STATE OF WASHINGTON
DEPARTMENT OF ECOLOGY

April 27, 2022

Re: Opinion on the Proposed Cleanup of a Property associated with the Asarco Tacoma Smelter Site

- **Property Name:** Redondo Heights
- **Property Address:** South 276th St., 600 feet east of Pacific Hwy S, Federal Way, WA 98003
- **Facility/Site ID:** 96556
- **Cleanup Site ID:** 15499
- **VCP Project No.:** NW3331

Figure 4. Remedial Area in the Sample Location DU1-08-06

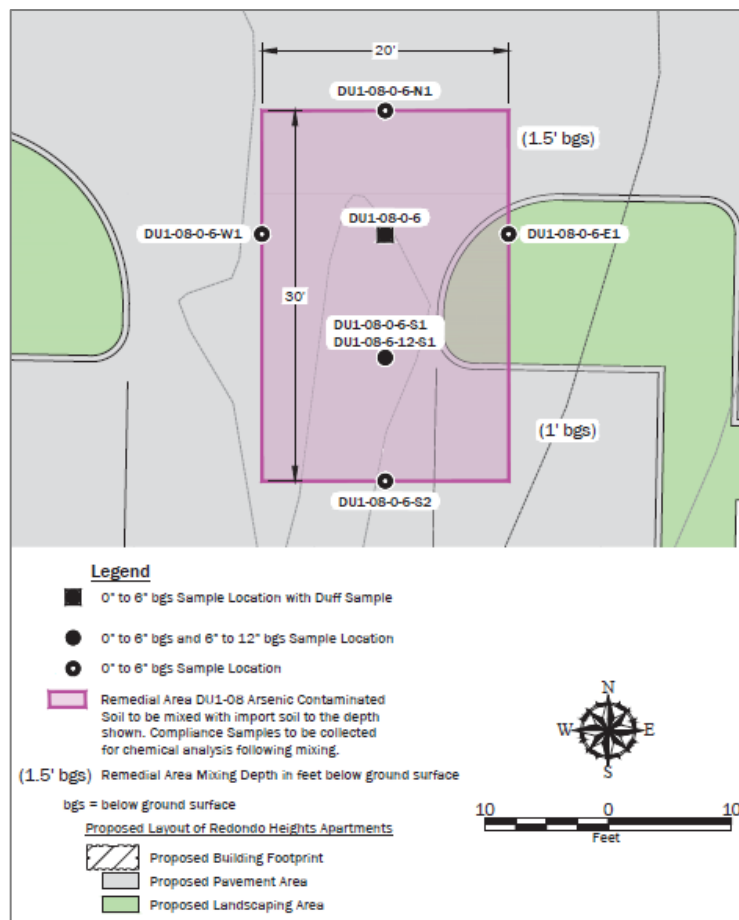
Based on the results of the characterization soil sampling, GeoEngineers identified one remedial area where arsenic exceeded twice the cleanup level of 20 mg/kg in the soil (sample location DU1-08-06). They also identified two locations, where the composite duff samples were at or above the cleanup level of 20 mg/kg for arsenic (DU1-32-Duff and DU1-14-Duff).

The approximate size of the soil remedial area based on the characterization and additional sampling is 20 feet wide by 30 feet long (Figure 4). The contractor will import approximately 11 cubic yards of clean soil and place it in a 5-inch layer over the remedial area. The contractor will mix the clean imported soil with 12 inches of the original soil to a combined depth of 18 inches bgs. The approximate volume of mixed soil will be 33 cubic yards.

If any of the samples exceeds twice the cleanup level of 20 mg/kg for arsenic or if the average concentration exceeds 20 mg/kg for arsenic, the contractor will conduct additional round of mixing. GeoEngineers will resample the mixed areas as described above.

Figure 5. Approximate Locations of the Two Areas with Elevated Arsenic in Duff (in red)

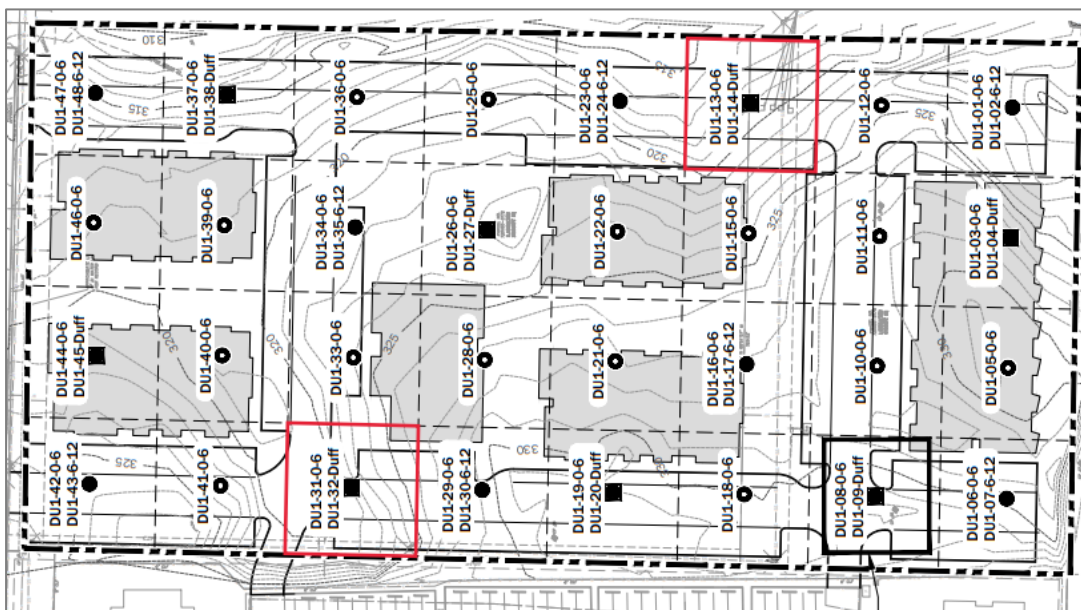
The contractor will scrape the duff from the two areas where arsenic was at or exceeded 20 mg/kg and dispose it off to a qualified disposal facility. The approximate dimensions of the two areas are 80 feet by 80 feet, each (Figure 5). Shelter will provide the receipt of the disposal with the cleanup report and a request for a No Further Action determination.
